**ZONING MAP CHANGE
STAFF REPORT**

City Council Meeting Date:
October 11, 2016

Site Location: 1001, 1003 & 1005 W. Rosedale St, 1100 blks Adams, College &
Washington Aves Mapsco: 76M

To: "PD/NS-T4" Planned Development for all uses in "NS-T4" Near Southside/General Urban uses with 6-story multifamily and parking garage; site plan included

W. ROSEDALE AND WASHINGTON SITE PLAN

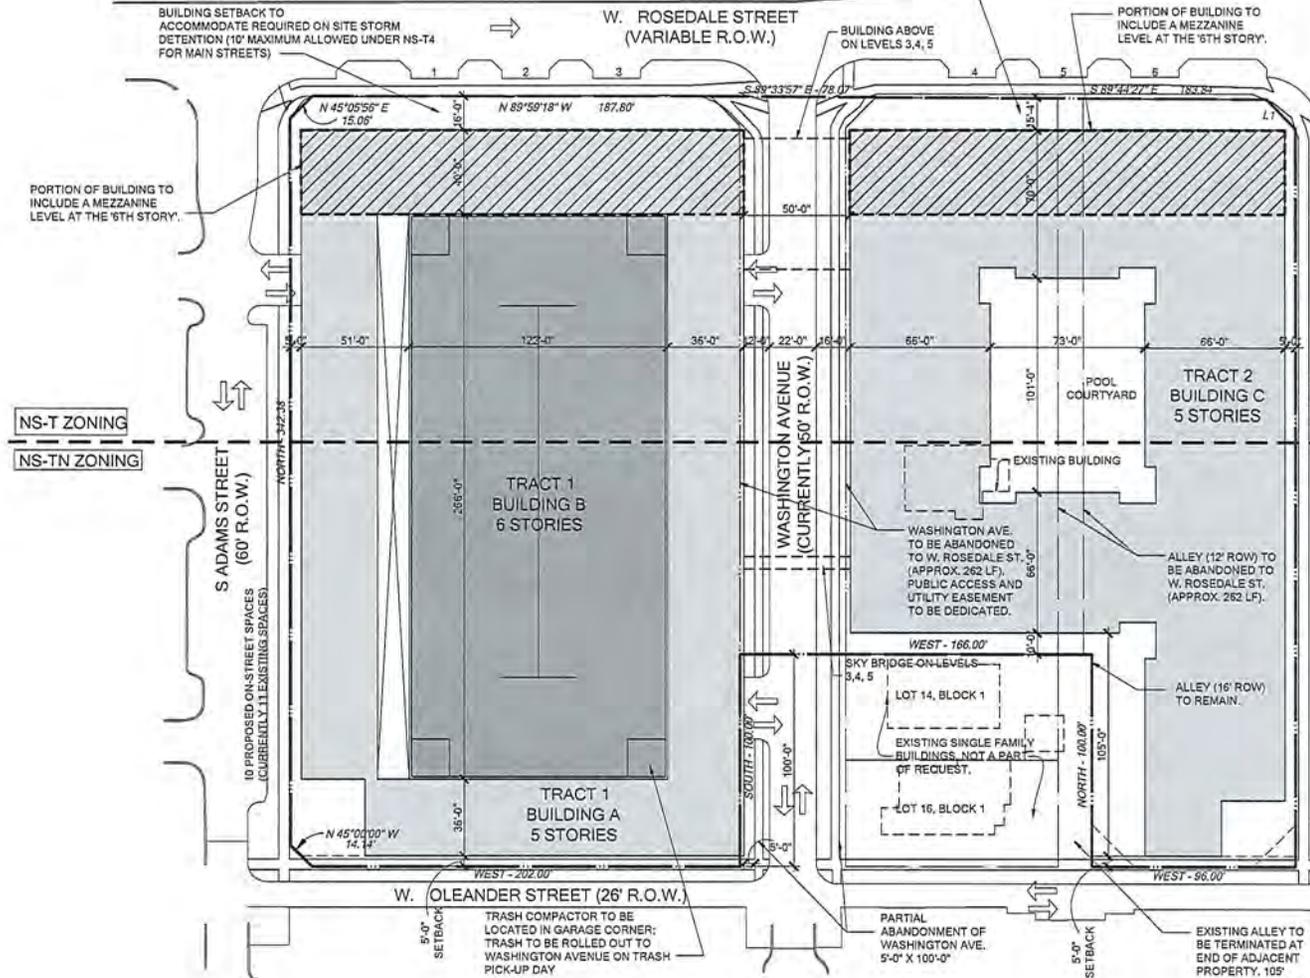
The site plan as submitted is not in general compliance with the Zoning Ordinance regulations. The deficiencies are:

1. Provide parking table with total number of units and parking provided
2. Exceeds maximum height of three (3) stories (applicant is proposing six (6) stories) **(waiver is required)**

Compliance with the items noted above shall be reflected on the site plan or waivers are required.

PARKING TABULATION	
TOTAL UNITS	391 UNITS
SPACES REQUIRED (1A PER UNIT)	548 SPACES
TOTAL SPACES PROVIDED	548 SPACES (NOT INCLUDING ON STREET PARKING)
